Planning Commission Meeting

September 12, 2023 6:00 PM

4.I. 558 Woodrow Avenue Site Plan Review

DATE: August 24, 2023
TO: Adrienne Senter
FROM: Lynn Patterson
RE: Site Plan Review – 558 Woodrow Ave

1
2A-1
NORTH ELEVATION (FRONT)
SCALE: 1/4" = 1'-0"
GRAPHIC SCALE

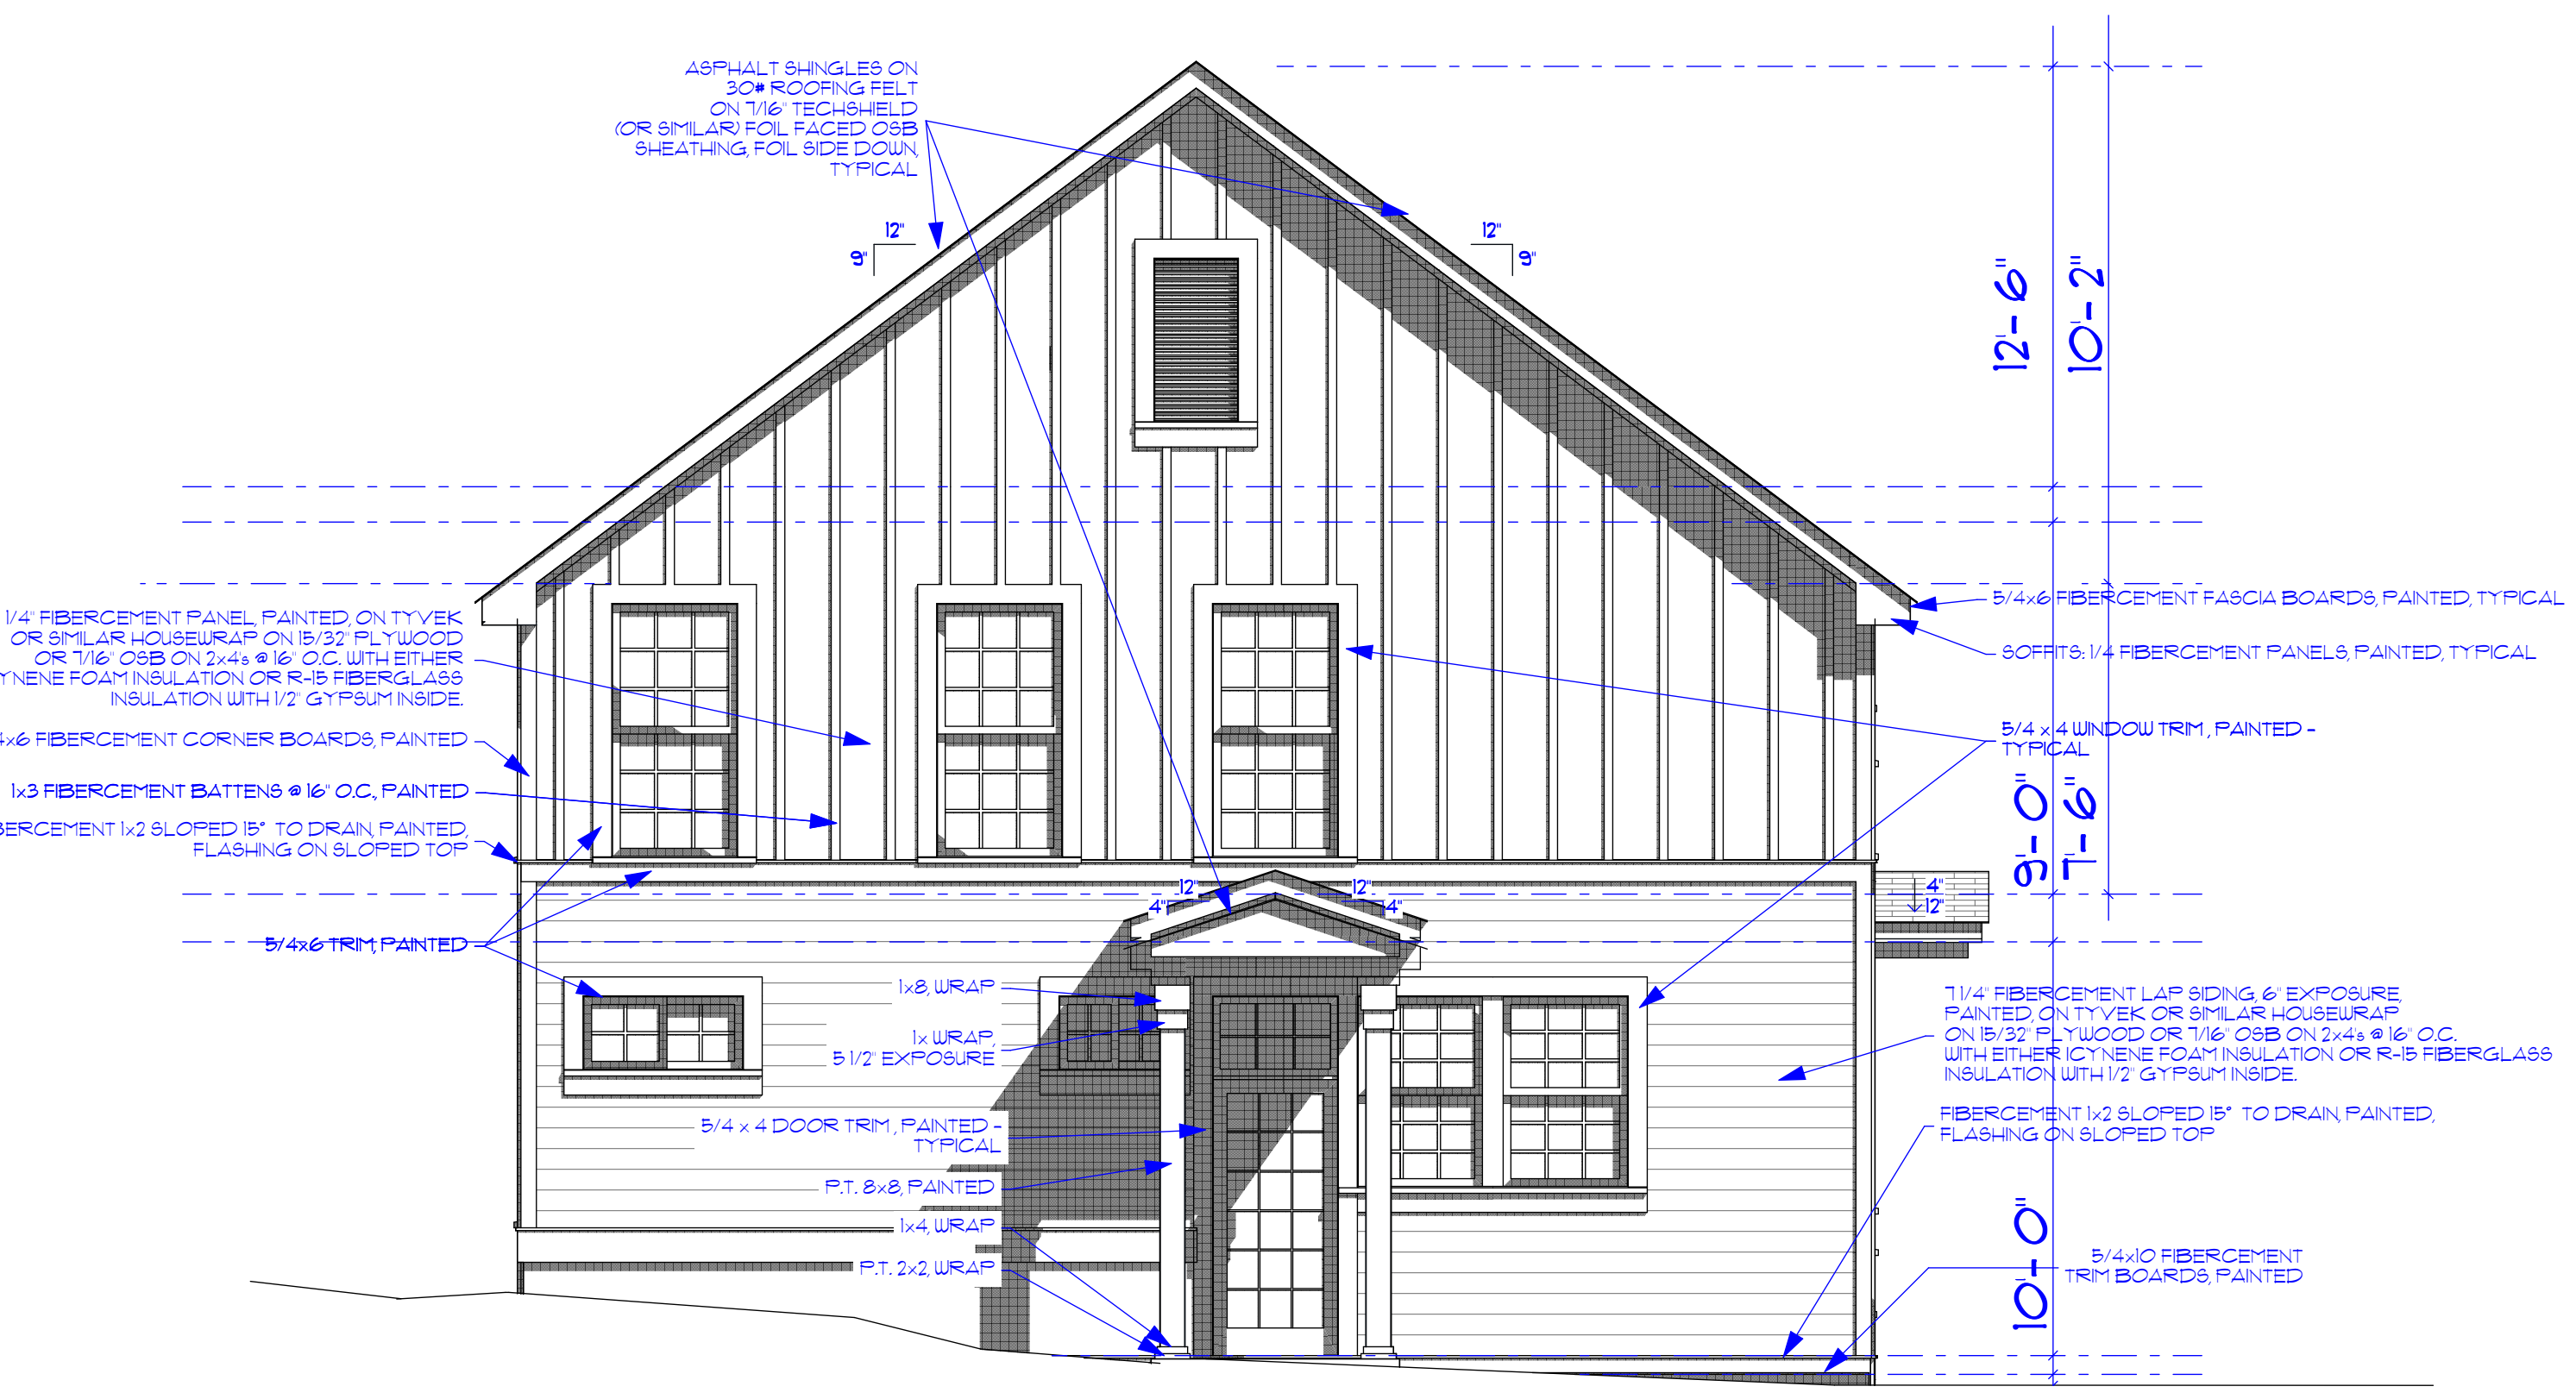
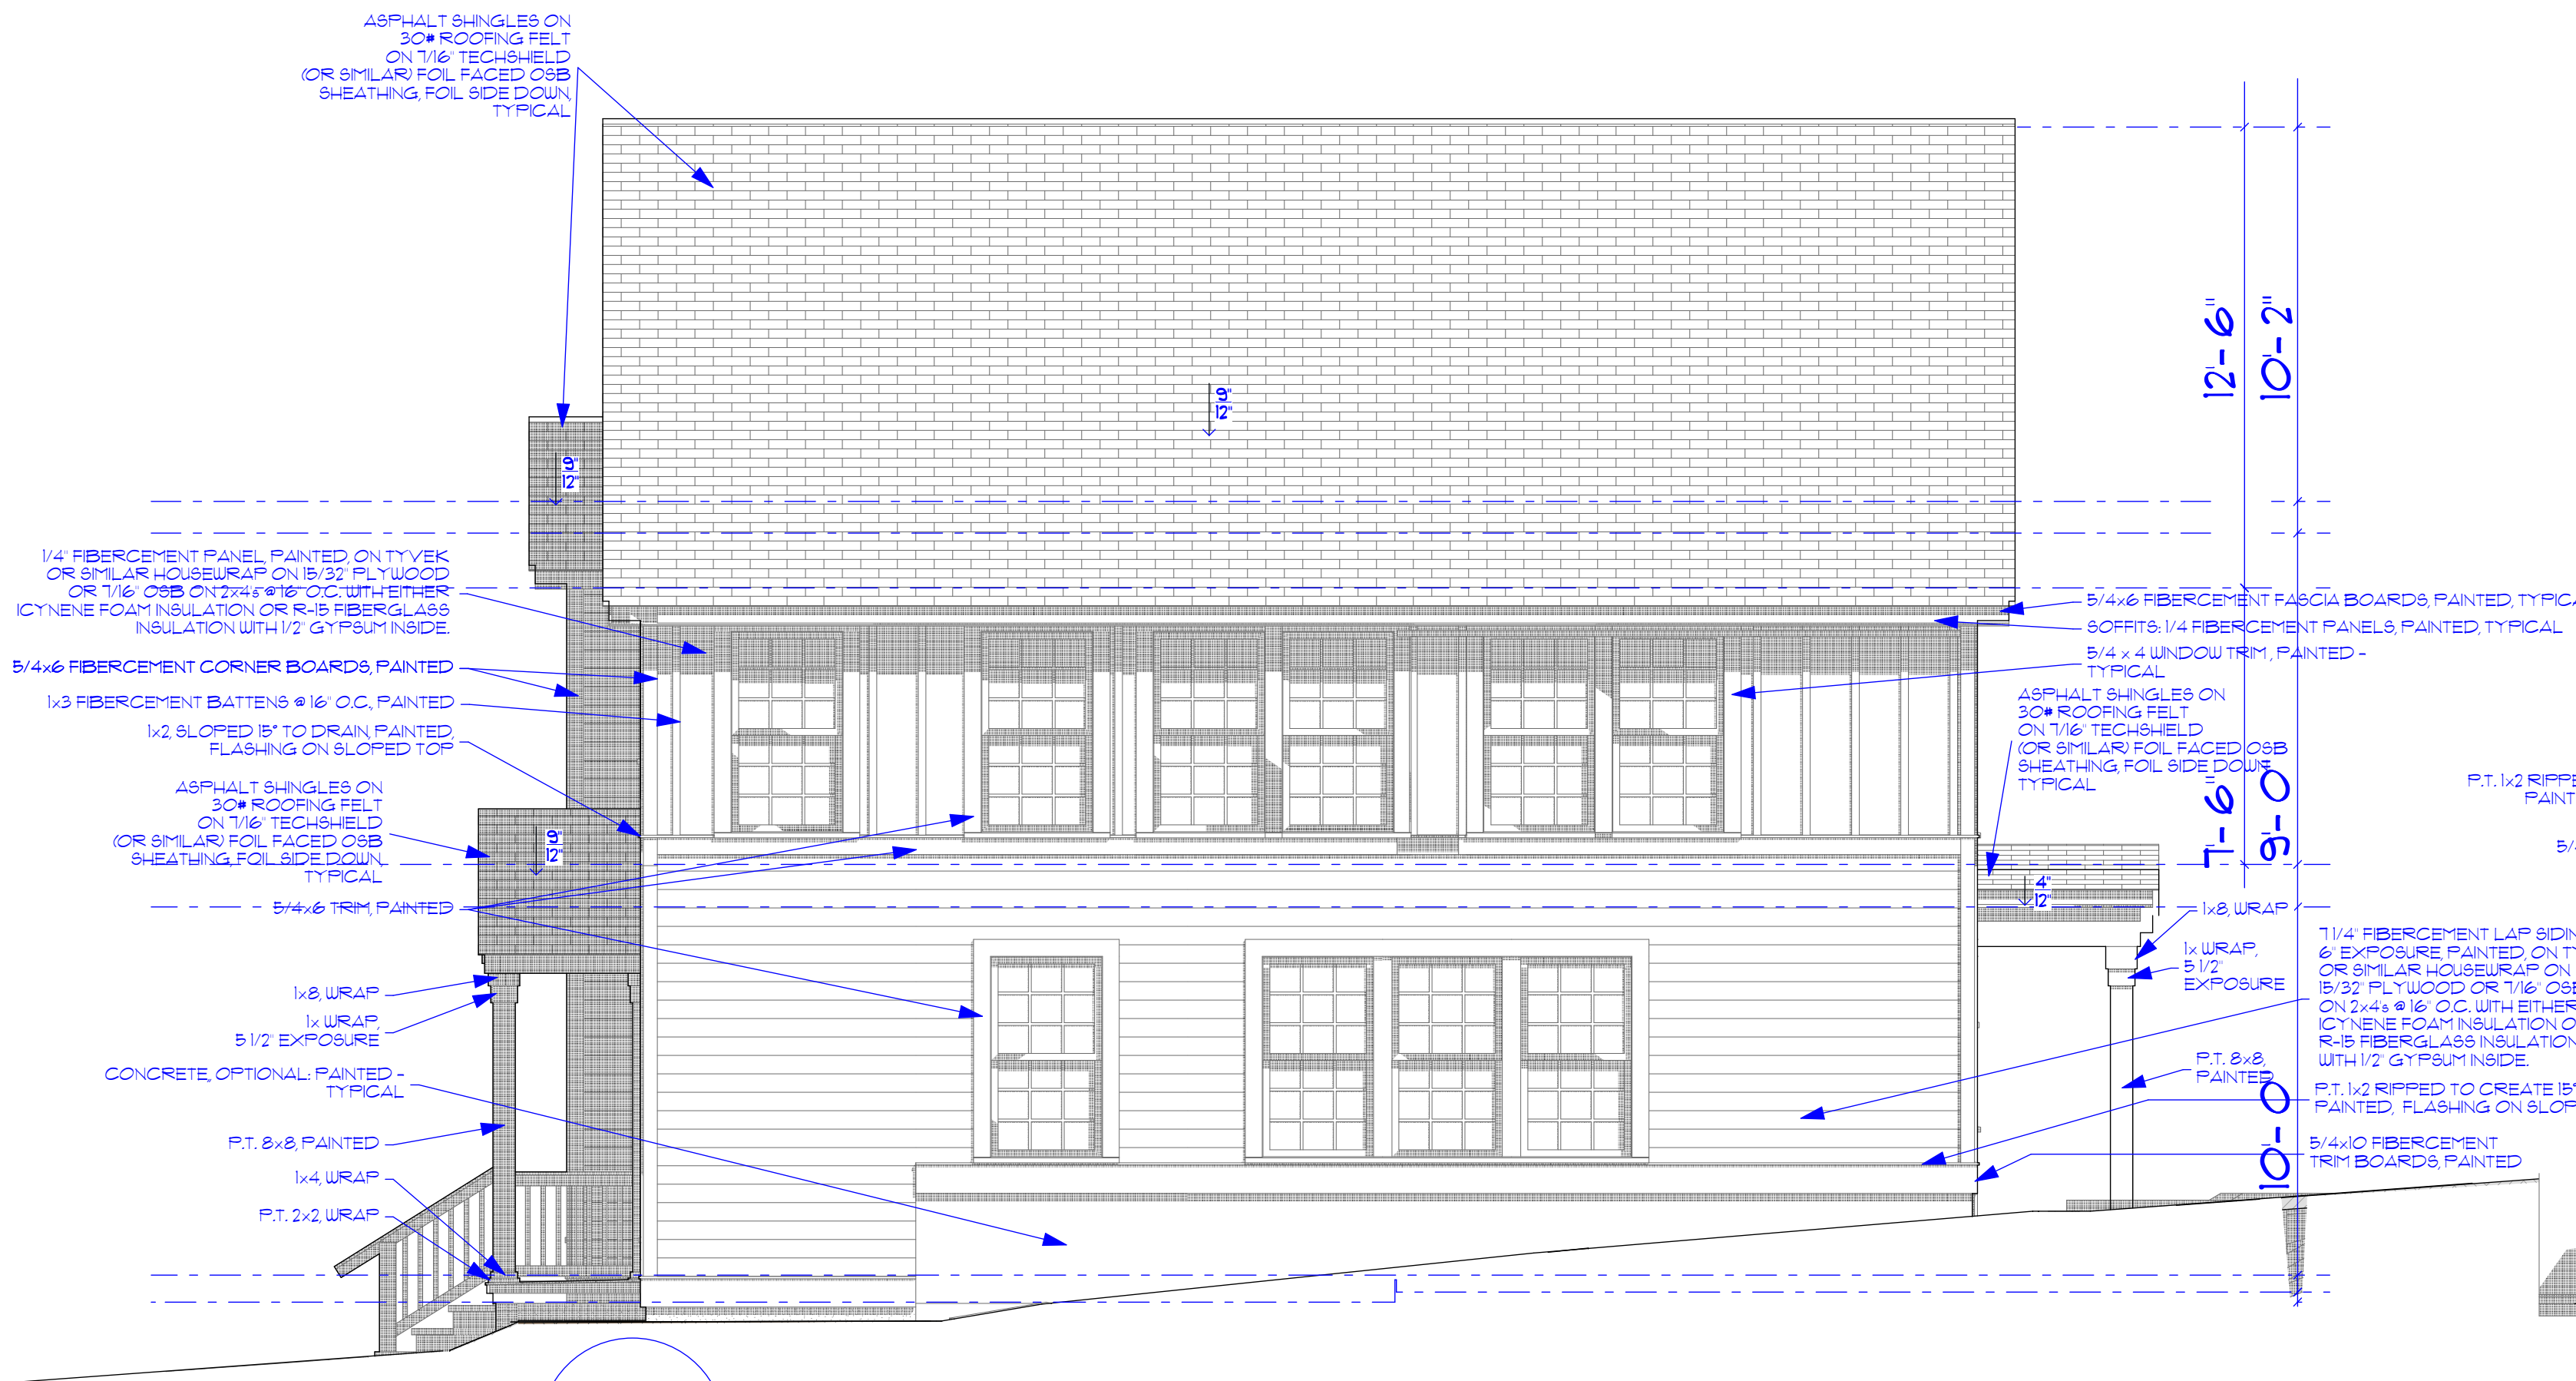
The City of Hapeville has received a site plan application from Avuntee Patel to construct a 2,319 SF single family residence at 558 Woodrow Avenue. There is an existing house which will be demolished to the foundation. The proposed dwelling has 4 bedrooms and 4 ½ baths. The height of the residence is not provided from the foundation to the front ridge (see 2A-1 North Elevation).

- ***The proposed new single family dwelling is shown as below the 35' limit from the front grade. Please provide actual dimension from grade.***
 - b. The location and general design cross section characteristics of all driveways, curb cuts and sidewalks including connections to building entrances.

- *Provide dimensions for concrete driveway including width, length, and length beyond front façade of house.*
- *Show the existing sidewalk on the site plan.*
- *Provide actual height from grade*
- *Provide front, side, and rear setback dimensions of house. Include front stoop/concrete steps as closest point for the front and eaves to the side and rear.*
- *Provide confirm eaves are not in the setback.*
- *Confirm if any on site grading will be done.*
- *Show rear setback dimensions.*
- *Provide a tree conservation plan.*
- *Provide a development schedule.*
